4	Landscape Addendum 2	MGN	26JUN25
4	Landscape Addendum 1	MGN	26JUN17
3	Issued for Tender	MGN	26MAY25
2	Issued for Permit	MGN	26MAY25
1	REV'd FOR COMMENT	MGN	26JAN16
No.	Description	By	Date

LANDSCAPE DETAILS

ONTARIO ABORIGINAL HOUSING SERVICES
321 JOHN STREET
COBOURG, ON

L4

1 ACCESSIBLE SEATING

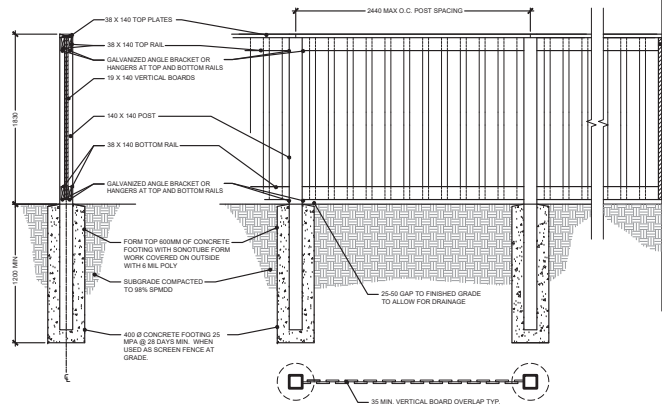
P.CO-319

ALL DETAILS THIS SHEET:
Submit shop drawings for review prior to fabrication. Shop drawings shall include all dimensions, materials, connections, anchorage, finishes, and installation requirements.
